21 February 2019

Huntlee DA Modification 10 – Response to Recent Comments

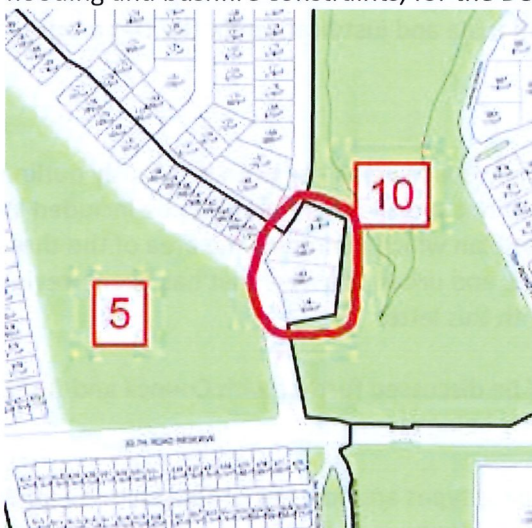
To enable a thorough assessment, the Department requests an overall plan showing all of the proposed changes (through clouds, red text etc). There are still a number of proposed changes that aren't clearly highlighted on the submitted plan. The Department is also still unclear about the lot numbers. It would be appreciated if these could be clarified again and reflect the overall lot numbers that are shown on the submitted masterplan.

Two additional plans have been provided clarifying the changes made to the masterplan in red markup and also confirming the total number of lots which is summarised below.

- Total residential lots - 1427
- Total commercial/mixed use lots - 43
- Total Infrastructure/community/ other lots - 8
- Total numbered lots - 1478

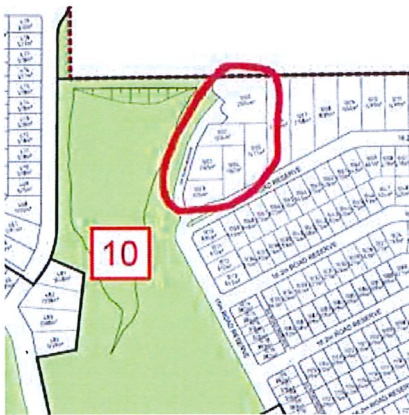
Please provide the RL's for the lots to the south of Precinct 1, that adjoins the existing North Rothbury subdivision, and demonstrate how any level changes can be dealt with within the proposed allotment boundaries without requiring large retaining walls.

It is understood that the Department is seeking clarification that the slightly increased density of lots will not require the provision of high retaining walls to enable house construction.

The surface levels of the subject lots are not excessive and no retaining walls are proposed to be constructed by Huntlee. The subject lots typically have a width of 22m or more, which is far more than an average sized residential lot. The grading of lots in this area remains consistent with the original Stage 1 Project Application.

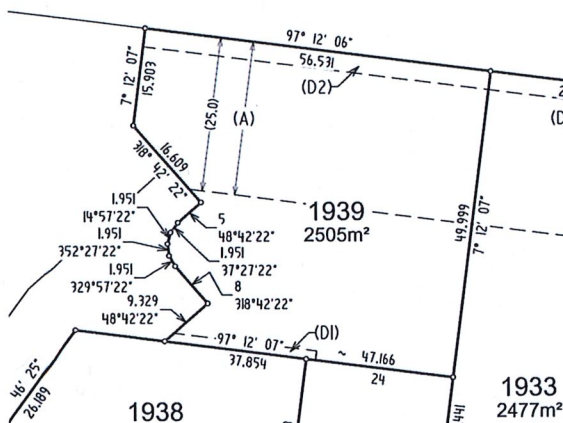
Modification 10 proposes to reduce the lot size and increase the number of lots in area of Precinct 10 indicated below. The Department raises concerns that Lot 1000 will not be able to accommodate a reasonable building envelope outside the bushfire risk from the north. Please consider amending the lot layout to address this issue for the Department's consideration.

A letter specific to this lot has been prepared by MJD Environmental which confirms the lot is not significantly impacted by bushfire. As outlined in the MJD letter, RFS have signed off on the Bushfire Report previously prepared which includes the subject lot.

As illustrated in the following figure, lot 1001 (lot 1939 on the below draft DP extract) will have a 25m APZ, this however still leaves a buildable area of approximately 25m x 44m, totalling some 1,100sqm. This is more than sufficient to accommodate a substantial dwelling and also would allow a dwelling to be constructed outside of the BAL 40 zone if desired by the future purchaser.
